**RE: 225 BUNGARRIBEE ROAD, BLACKTOWN (DA-21-00558)
KRISHATHI PTY LIMITED -V- BLACKTOWN CITY COUNCIL (LEC CASE NO. 2021 / 146814)
LETTER OF RESPONSE TO TRAFFIC CONTENTIONS**

We refer to recent correspondence concerning the abovementioned Court proceedings and the Statement of Facts and Contentions (SOFC) issued by Blacktown City Council (Council) dated 14/07/2021, relating to the deemed refusal of Development Application, DA-21-00558.

Ground Level Plan

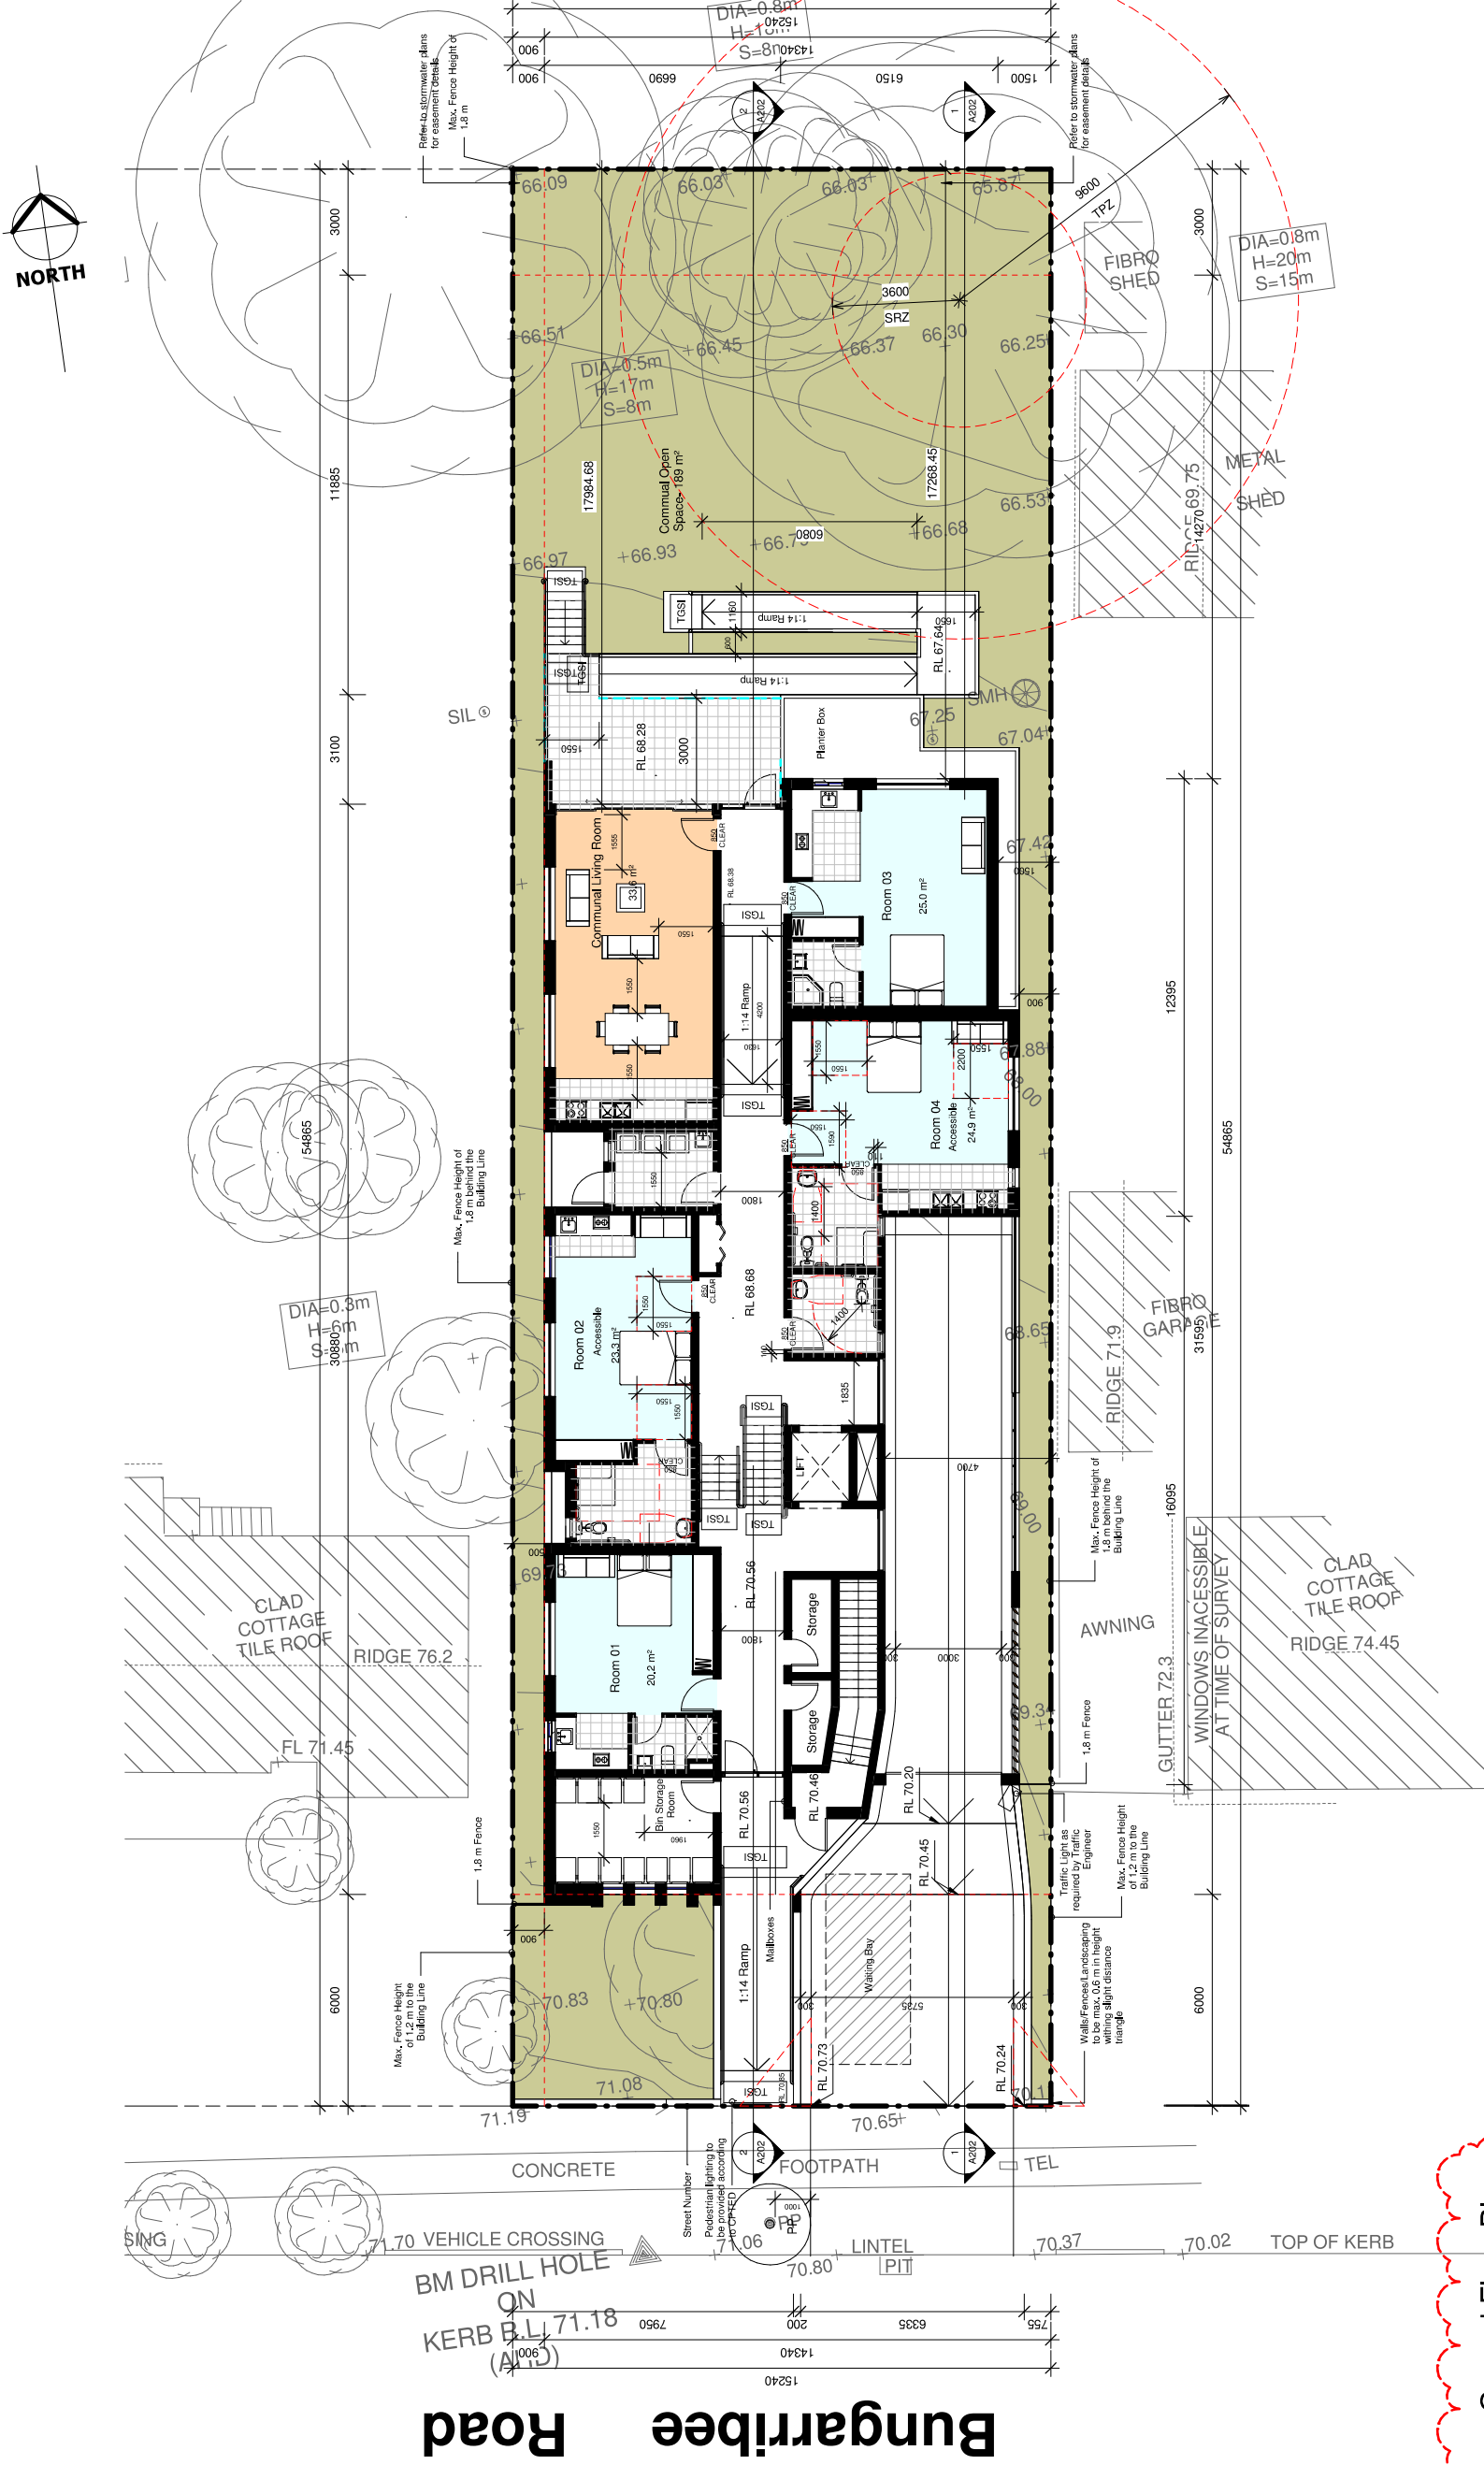
a) Sufficient provision for adequate sight distance needs to be made for both pedestrian and vehicular movement in accordance with Section 3.2.4 AS 2890.1, Figure 3.2 of AS2890.1 and Figure 3.3 of AS2890.1 to ensure safety of pedestrians on the footpath system and motor vehicles along the new driveway.

c) There are no mitigation measures proposed to manage two-way passing along the single width ramp and within the basement car park. Vehicles entering the site will be unable to see a vehicle leaving the Site and will not know to enter the passing bay upon entry. This will result in reverse movements back out onto Bungarribee Road, contrary to the design requirements within AS2890.1. Any proposed mitigation measures to manage two-way passing conflicts will need to be assessed to ensure vehicle queuing does not occur on the public road or verge.

The amended drawings included in **Attachment 1** demonstrate the development will provide a compliant 2.5 metre x 2.0 metre visual splay on the egress side of the driveway in accordance with Figure 3.3 of AS 2890.1. The existing fence along the eastern boundary will be demolished and replaced with a new fence having a maximum height of 600 mm ensuring that compliant sight distances are achieved between exiting motorists and any pedestrians that may be walking along the northern footpath of Bungarribee Road.

The amended drawings included in **Attachment 1** indicate that a traffic signal system will be provided to manage two-way traffic flow along the one-lane ramp. The traffic signal system will ensure that only one vehicle travels along the ramp at any one time and result in a safe design outcome.

Nevertheless, we note that the amended drawings included in **Attachment 1**, demonstrate that the 7.7 metre aisle width within the basement substantially exceeds the minimum 5.8 metre aisle width required under AS 2890.1. The increased aisle width, in combination with the compliant car parking layout, provides ample space for vehicle manoeuvring as demonstrated by the updated swept path results included in **Attachment 2**.
